CITY PLAN COMMISSION STAFF REPORT

CD-CPC-2026-00023

5019 Raytown Road

Plan Conditions, Corrections, & Suggestions Report

LANDSCAPE PLAN

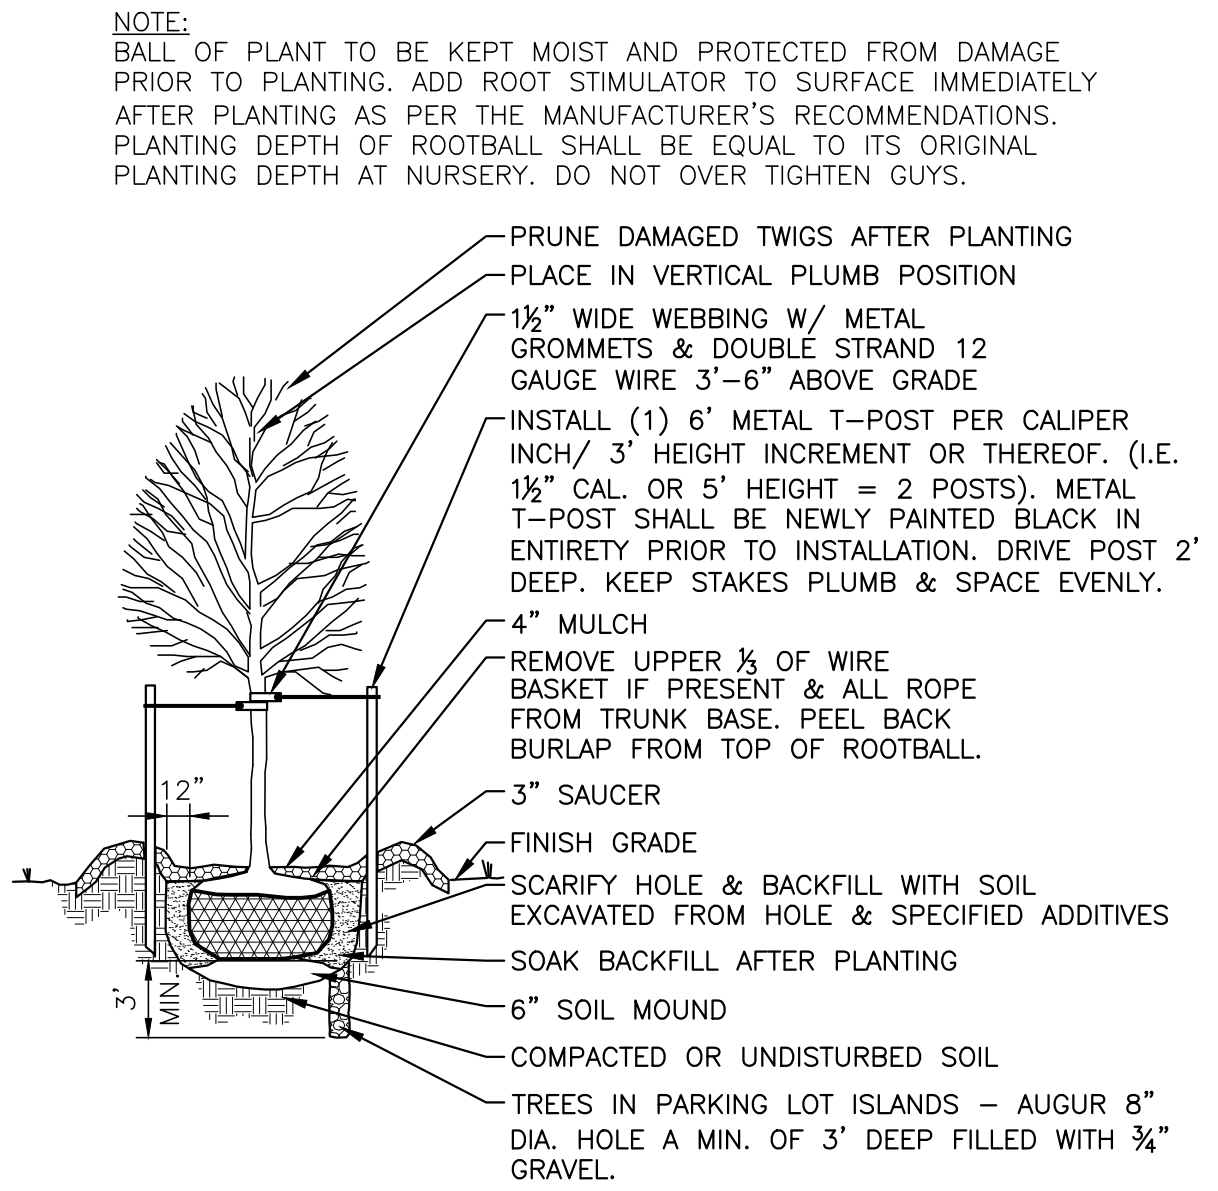
4. Vehicular use areas adjacent to residential zoning districts must be landscaped. Follow 88-425-05-C. Bushes or hedges on the rear property line adjacent to rock island trail to screen the use from the trail and residences. Use native species. UPDATED 4-2-2026: Landscaping shown does not comply with code. Provide a data table with all required information such as species, size, and quantity, and include a legend and appropriate markers in the proposed area. All landscaping must be native as stated in the code. (4/10/2026)

17. The applicant shall revise the landscaping plan to include additional screening style landscaping at the rear of the property in addition to the existing fence as the parking area is higher than the Rock Island Trail and vehicle storage will be in view from the trail. This shall be completed prior to ordinance request. (4/03/2026)

18. The applicant shall revise the plans to show landscaping along the northeastern side of the lot abutting the Rock Island Trail with landscaping that is compliant with 88-425-05-C or shall apply for and receive approval of a an administrative adjustment for the landscaping prior to ordinance request. Landscaping & Screening (4/09/2026)

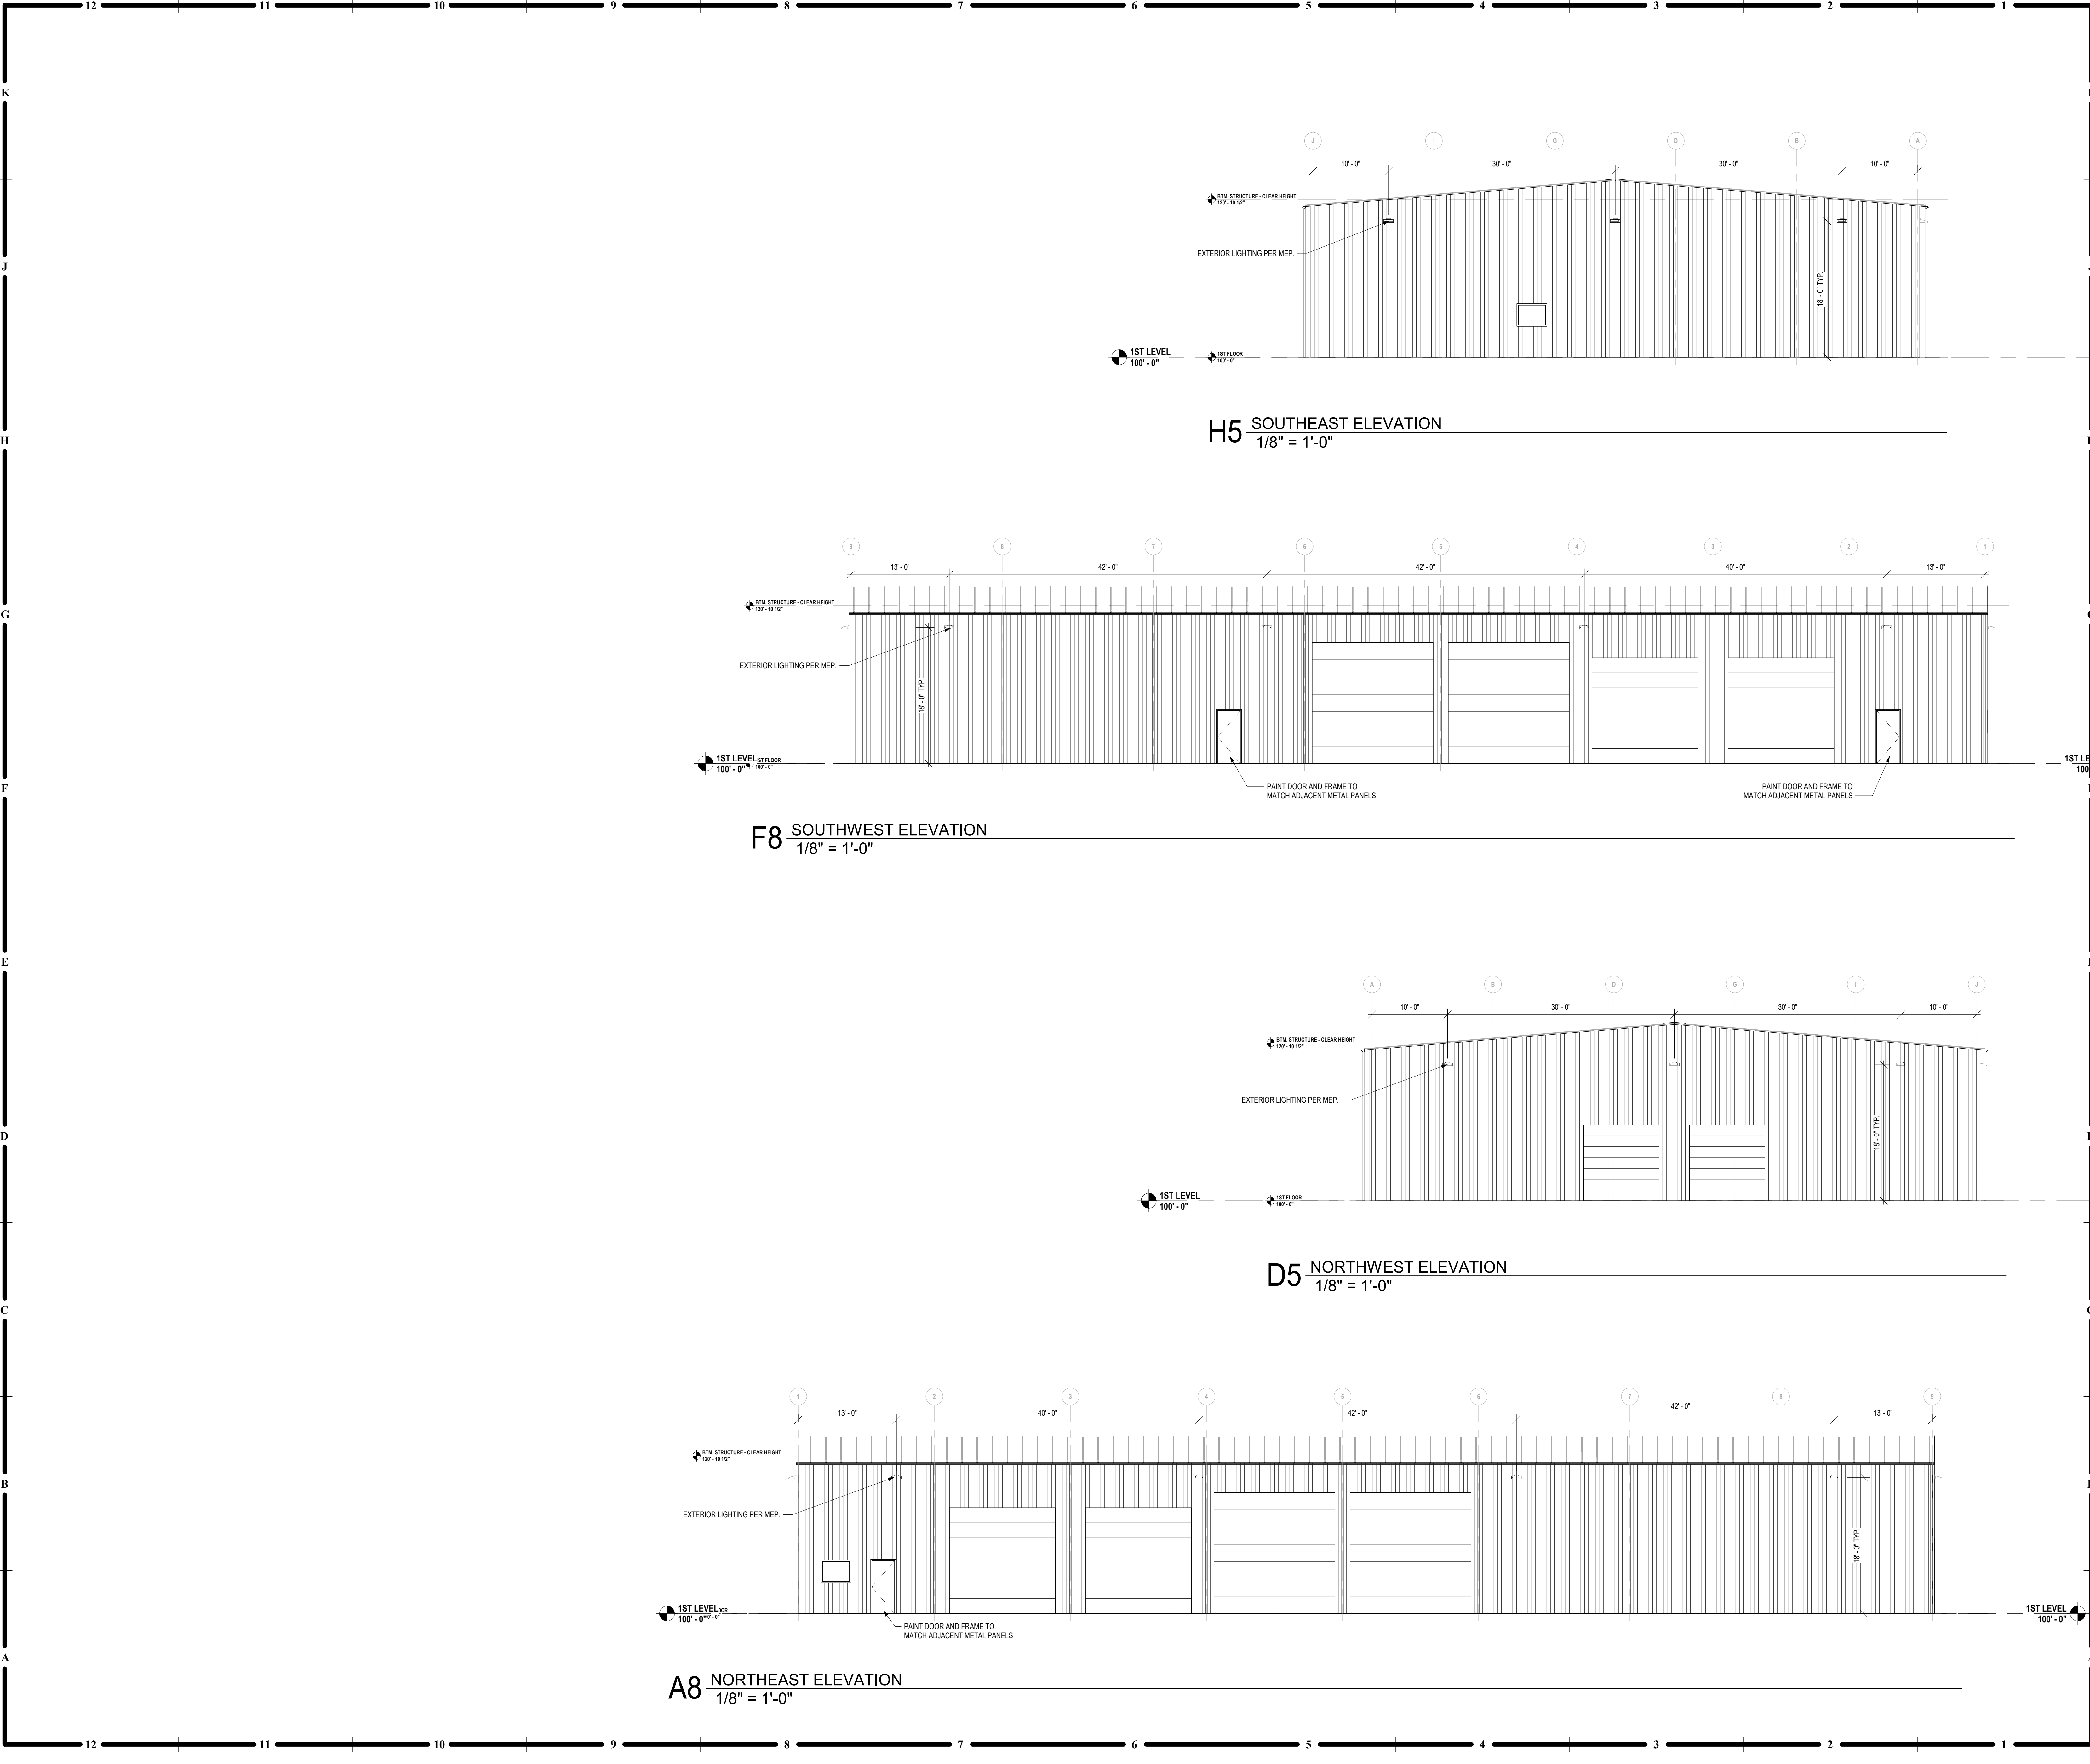
15. The applicant shall revise the building elevations to apply high quality building materials including but not limited to brick, stone, cast stone, finished concrete, stucco (not EIFS), metal (not sheet or pan style), or cement board to the front facade of the proposed building facing Raytown Road to increase alignment with design guidelines in the area plan and KC Spirit Playbook and Raytown Road's identified Image Street status. This shall be completed prior to ordinance request. (4/03/2026)

16. The applicant shall revise elevations to add eye-level windows with two-way transparency, clerestory windows, or material changes to the front facade of the proposed building facing Raytown Road to better align with the Well-Designed City goal of the KC Spirit Playbook. Denote on the elevations the material type and location on the elevation drawings. This shall be completed prior to ordinance request. (4/03/2026)
